**PERMIT**  
**INDEXED**  
04-309499

**ON-SITE SEWAGE DISPOSAL SYSTEM**  
**HOWARD COUNTY HEALTH DEPARTMENT**  
**BUREAU OF ENVIRONMENTAL HEALTH**

SUBDIVISION: River Farms LOT NUMBER: 21, Sec. 2

ADDRESS: 2929<sup>1</sup> Duvall Road PROPERTY OWNER: Dave Randlett

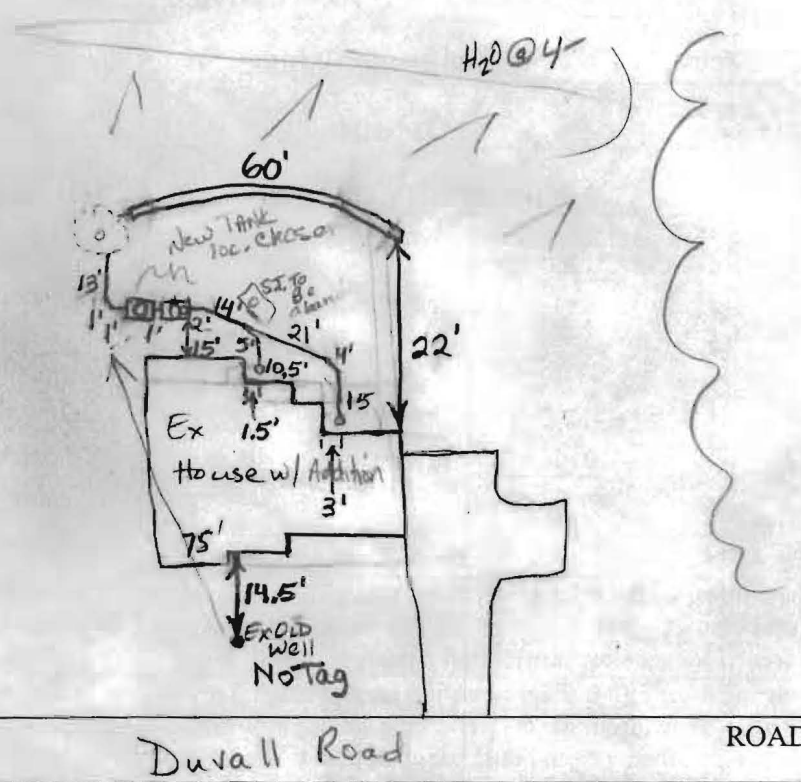
Repair area on other side of gully SEE REC NOTES

PRE-CONSTRUCTION 10-4-04 S.TANKS TO BE PLACED NO CLOSER THAN 75' to ex well. Place two S.TANKS in succession & connect to Drywell.

INSTALLATION Run 1-47' long trench on contours. Cave in ex. ST. - NOT functioning properly (KD) 10/5/04 House connections needed. Manhole cleanouts not installed. Trench mostly backfilled but it looks like it is about 60' in length. No one from Trojes at site. (BB) 10/6/04 Cleanouts put on tanks. Still need house connections. (BB) 6/22/05 System approved without verifying house connections. File can be indexed. (BB)
